**CITY OF PORTLAND**

Permit Number: 070913

This is to certify that PIXLEY ANDREW C /Jayson Cundowhas permission to 14' x 12' rooftop deckAT 705 CONGRESS ST

<b>Proposed Use:</b> 1 commercial restaurant on the 1st floor and 4 residential condos in the rest of the building - new 14' x 12' rooftop deck for condo #4	<b>Proposed Project Description:</b> 14' x 12' rooftop deck for condo #4
---	---

THE DECK PLAN  
 PALERMINO DECK  
 RAY  
 REGISTERED PROFESSIONAL ENGINEER  
 105 CONGRESS ST. SUITE 4 PORTLAND, MAINE  
 405-777-1100

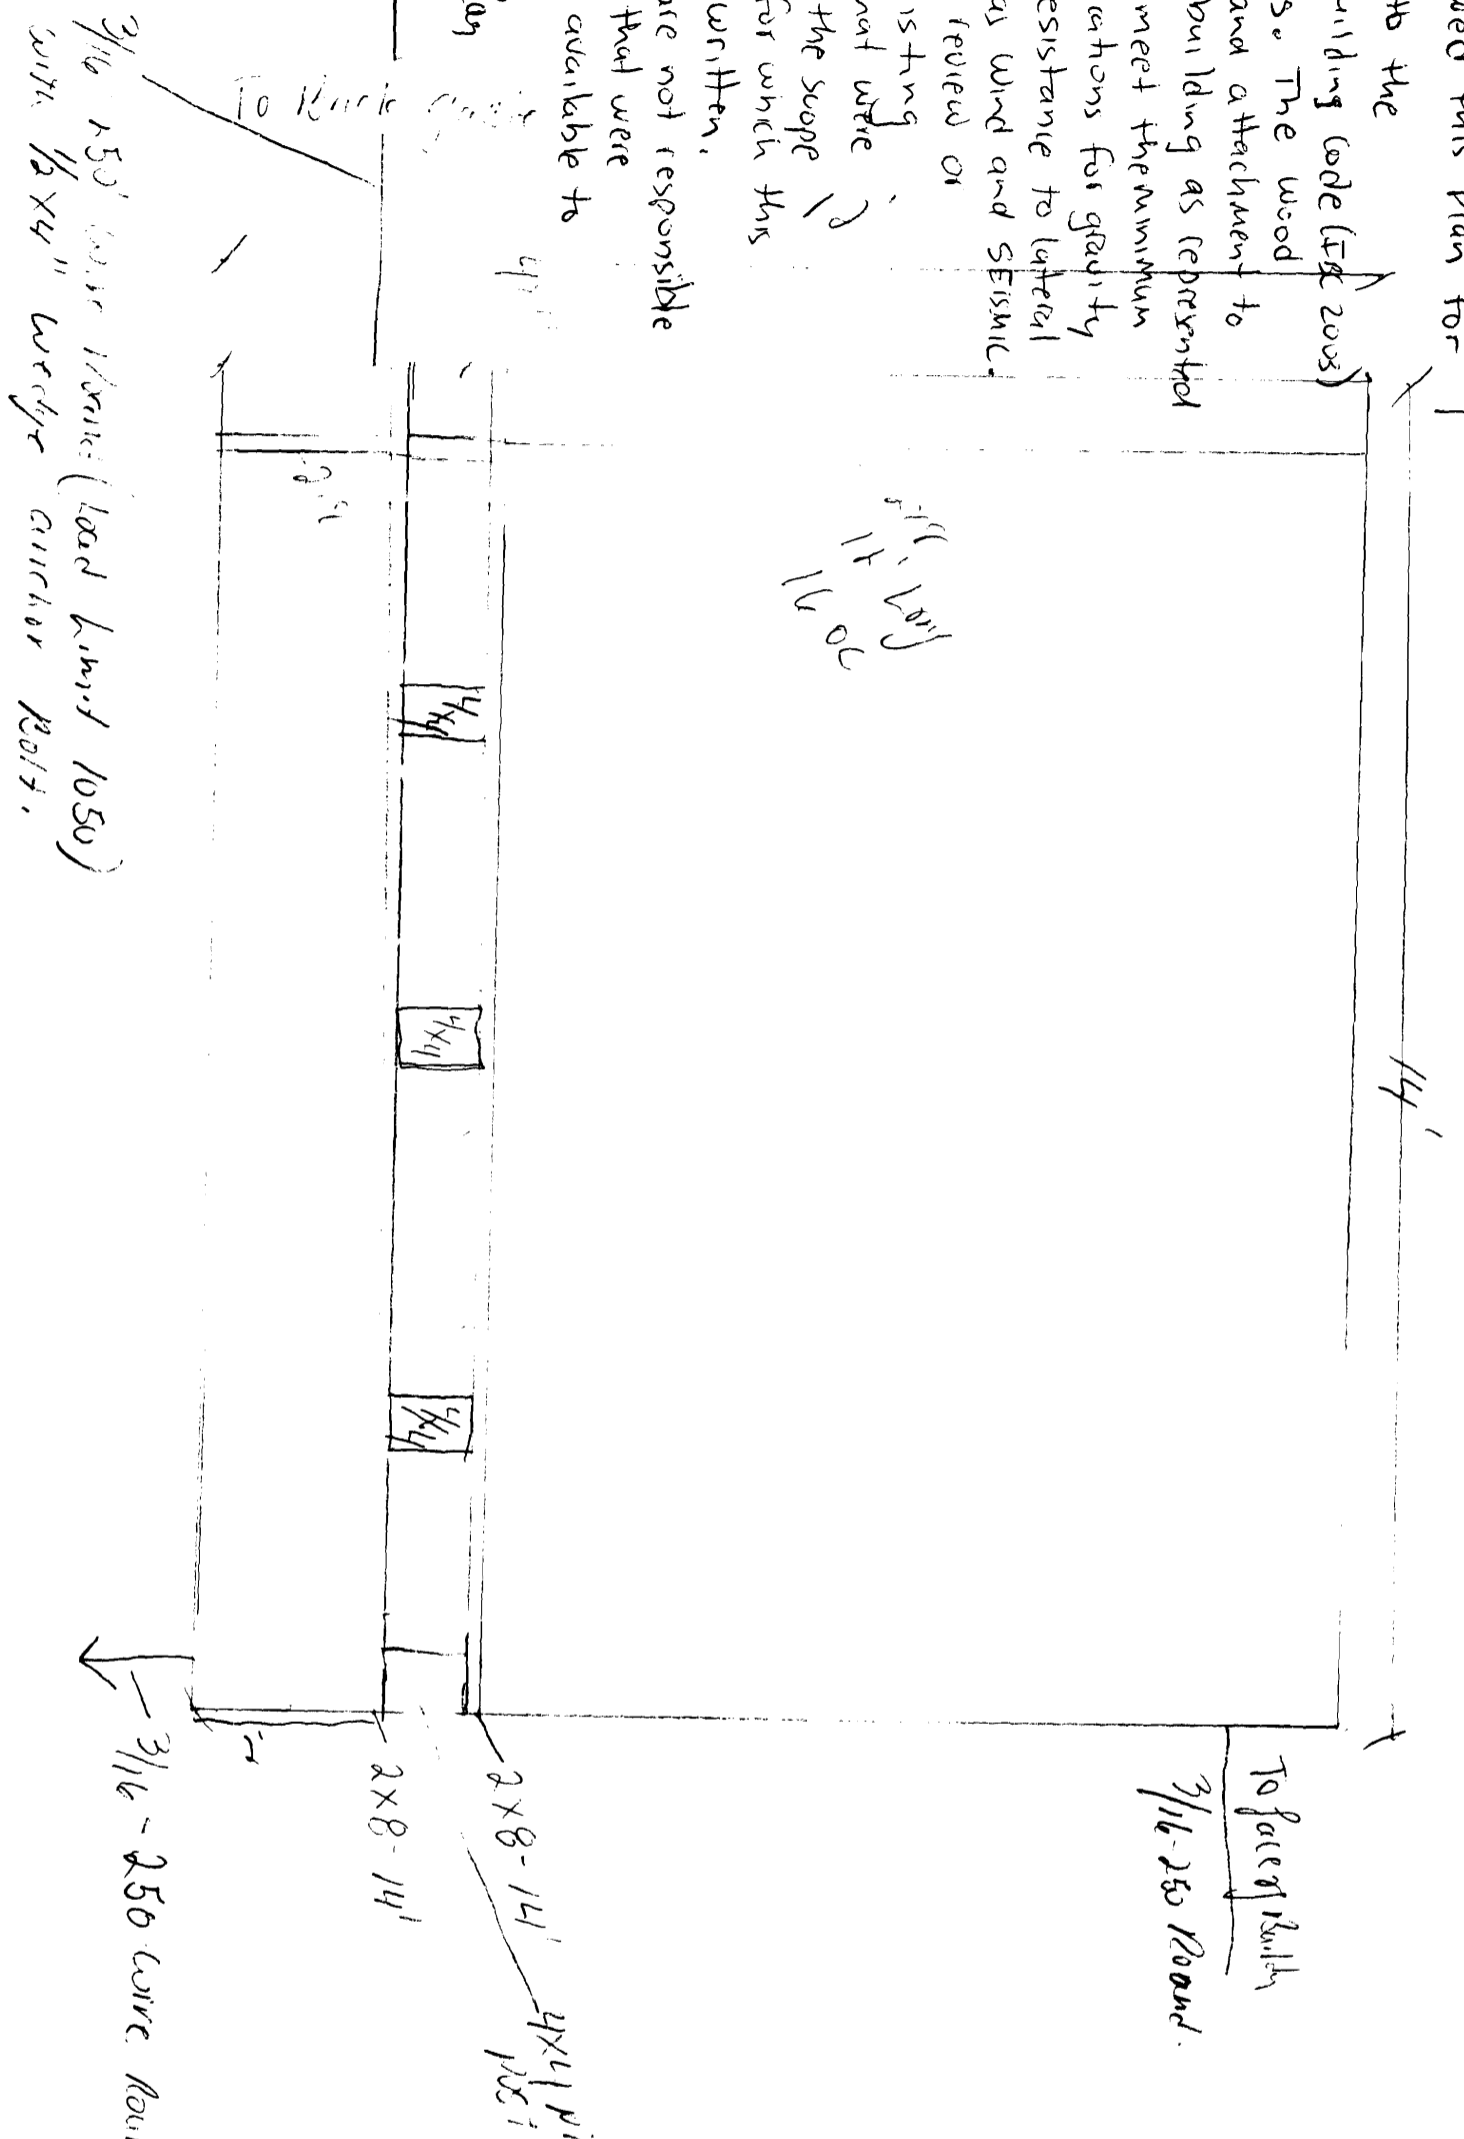
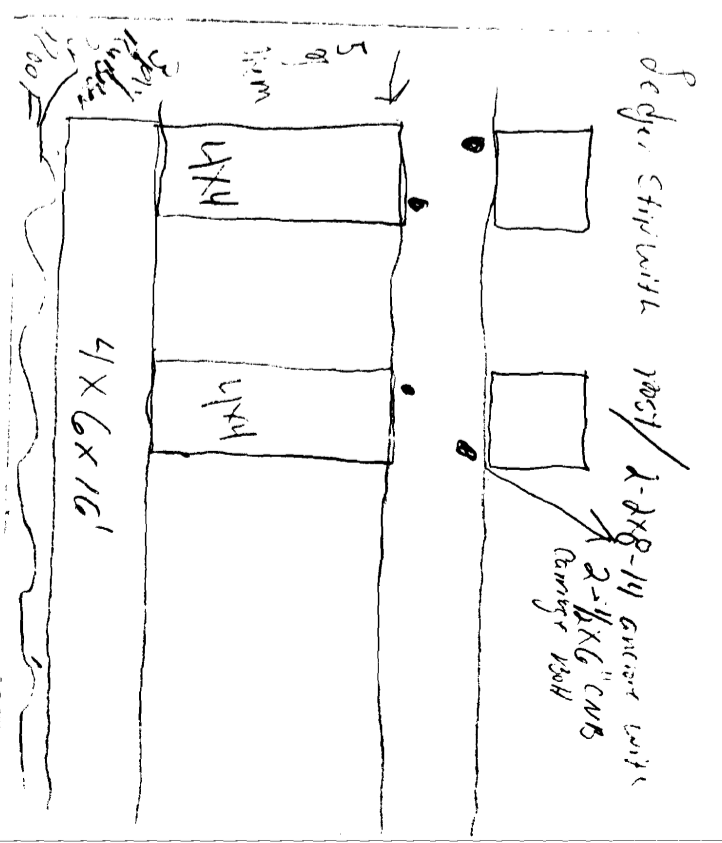
*Refer to submittal on plot for details*

We have reviewed this Plan for Conformance to the International Building Code (IBC 2003) Structural loads. The wood Framed Deck and attachment to the existing building as represented on this Plan meet the minimum design Specifications for gravity loads and resistance to lateral forces such as wind and seismic. We did not review or evaluate existing conditions that were not within the scope of services for which this review was written. Therefore we are not responsible for conditions that were unseen or not available to review.

**NOTE:** This plan was reviewed for adequacy of existing structure to support imposed loads by proposed construction of wood Decking. Contractor shall verify installation of all anchors into existing structure and report to Engineer deteriorated or inadequate Existing conditions.
